MC-2006-0389

**Manager of the Manufactured
Housing and Modular Units
Program of the
Public Service Commission,
Complainant,**

**Blakely Manufactured Homes,
Respondent.**

**Complaint Regarding the Set Up and Installation of the
Modular Unit Home purchased by Larry and Joyce King.**

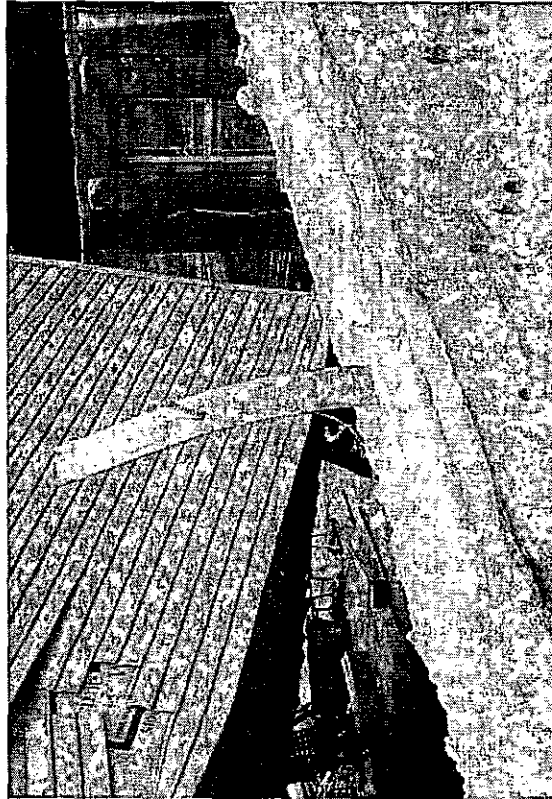
Blakely failed to properly attach the Kings' home onto the basement foundation in accordance with manufacturer instructions. This is a violation of: 4 CSR 240-123.065(1) which provides "A dealer who sells a modular unit shall arrange for the proper initial setup of the modular unit . . ."; and 4 CSR 240-123.065(2) "As used in this rule, 'proper initial setup' means installation and setup of the modular unit in accordance with the installation manual provided by the manufacturer of the modular unit and in complete compliance with the code and with all of the provisions regarding setup in sections 700.010 to 700.115, RSMo."; and, 4 CSR 240-123.080(7) which provides that "all modular units . . . shall be set up or installed according to the manufacturer's installation manual."

Fig 5.0

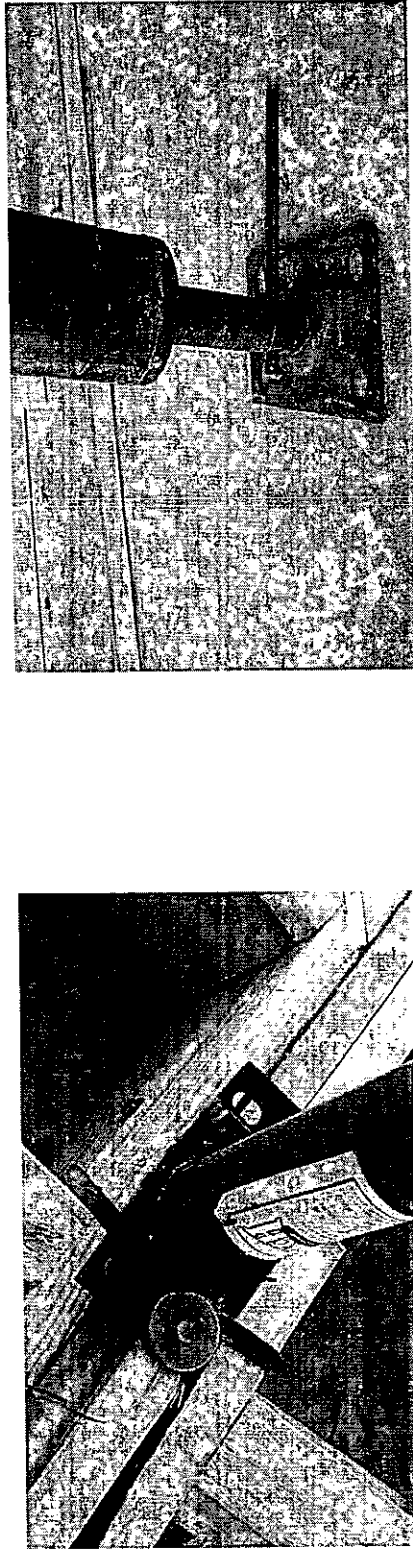
Blakely failed to properly attach the supporting jack posts to the home's center beam and to the concrete footing according to the manufacturer's foundation drawings. This is a violation of: 4 CSR 240-123.065(1) and (2) and 4 CSR 240-123.080(7).

MANUFACTURER INSTALLATION MANUAL PAGE 22

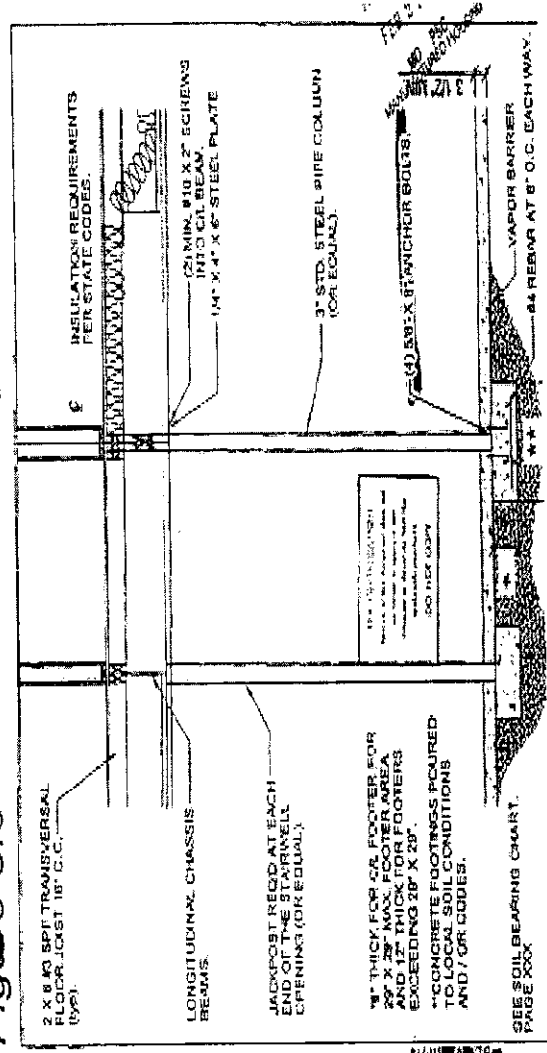
Blakely failed to properly fasten the home's hinged roof according to manufacturer installation instructions. This is a violation of: 4 CSR 240-123.065(1) and (2) and 4 CSR 240-123.080(7).

RAISING THE ROOF. The roofing system weighs several hundred pounds and can cause severe bodily harm or death in the event of a collapse. Insure that no portion of your body is under the roof while it is being raised. Use jacks with a minimum working load of 800 (eight hundred) pounds. Place one jack at each end, within 2'-0" (two feet) of the endwall. Place additional jacks at 12'-0" (twelve foot) intervals. A 76'-0" home will require 7 (seven) jacks to lift the roof. A crane with at least 3 straps is an alternative method of lifting the roof, in place of jacks. Begin raising the roof in a smooth, even manner. To avoid injury and/or damage to the home FOUR SEASONS does not recommend that persons lift the roof by hand. Do not let a portion of the roof sag excessively. Once the roof has been raised to the proper height, swing the hinged supports into place and fasten the 2X3 center rail into the kingpost stub using 2 (two) #8X3" wood screws toe screwed at each truss.

A) ALTERNATE RIDGE CAP DETAIL

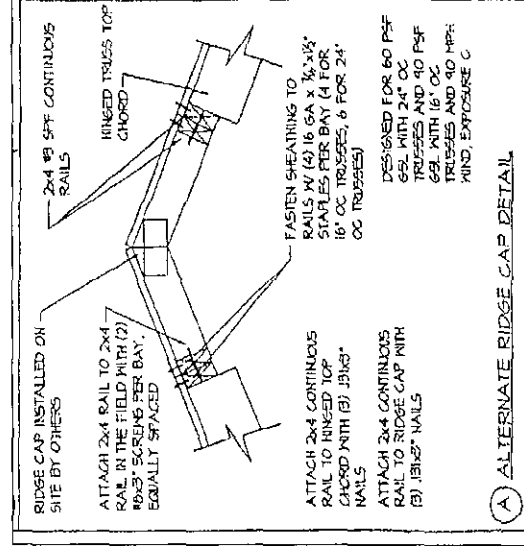
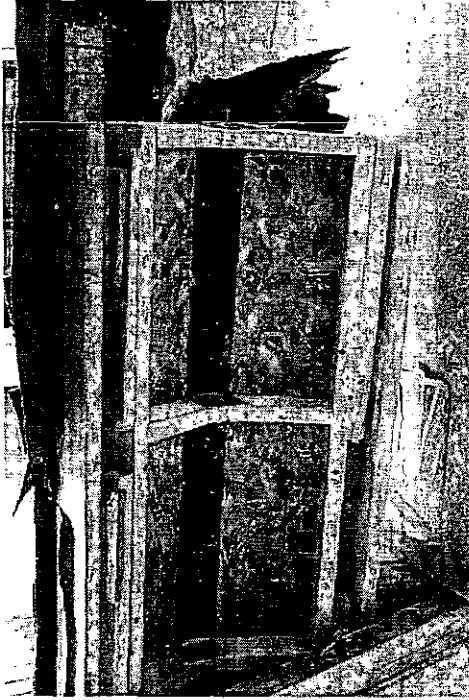
Blakely failed to properly fasten in place the drop-in roof ridge sections of the home in accordance with manufacturer installation instructions. This is a violation of: 4 CSR 240-123.065(1) and (2) and 4 CSR 240-123.080(7).

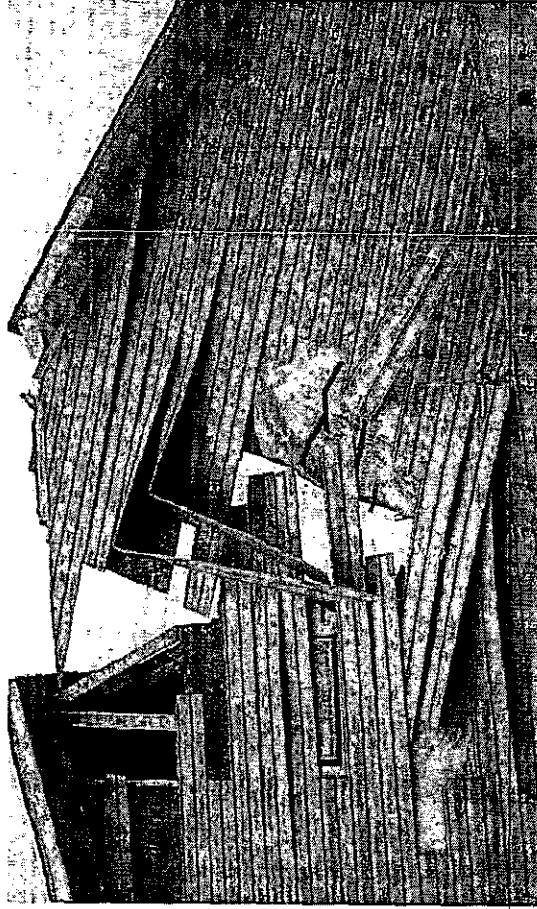
Blakely failed to properly fasten together the end walls of both home sections in accordance with manufacturer installation instructions. This is a violation of: 4 CSR 240-123.065(1) and (2) and 4 CSR 240-123.080(7).

3.7.5.1.3 END WALLS. Fasten the end walls using #8 x 3" screws at 12" O.C.

LOCATION	FASTENER	SPACING
Perimeter Joist	5/16" x 3" Lag bolt w/ washer	48" O.C.
Ridge	3/8" x 5" Lag bolt @ 45 degrees	48" O.C. Zone 1
Endwalls	#8 x 3" screw	12" O.C.

R316.1 & R316.2 2000 IRC

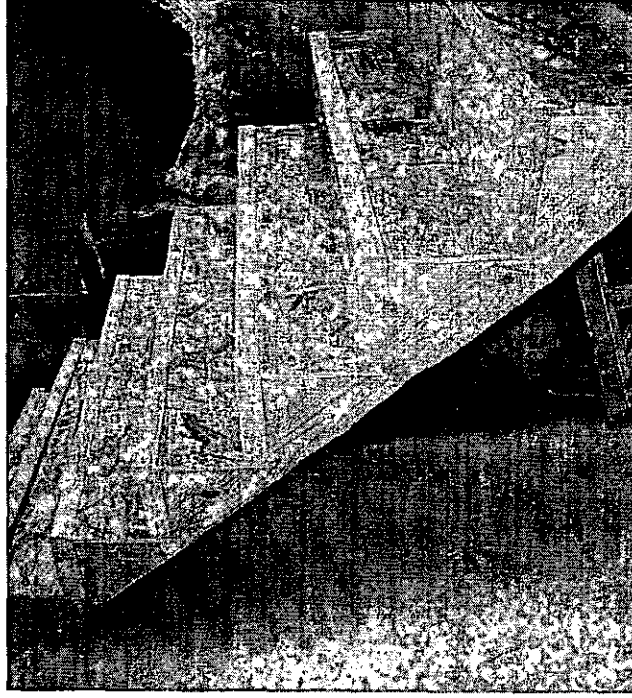
Blakely failed to install guards on the sides of the home's basement stairway in accordance with the International Residential Code-2000. This is a violation of: 4 CSR 240-123.080(3) and (4) and 4 CSR 240-123.065(1) and (2) and 4 CSR 240-123.080(7).

R316.1 Guards required. Porches, balconies or raised floor surfaces located more than 30 inches (762 mm) above the floor or grade below shall have guards not less than 36 inches (914 mm) in height. Open sides of stairs with a total rise of more than 30 inches (762 mm) above the floor or grade below shall have guards not less than 34 inches (864 mm) in height measured vertically from the nosing of the treads.

R316.2 Guards opening limitations. Required guards on open sides of stairways, raised floor areas, balconies and porches shall have intermediate rails or ornamental closures that do not allow the passage of a sphere 4 inches (102 mm) in diameter. Required guards shall not be constructed with horizontal rails or other ornamental pattern that results in a ladder effect.
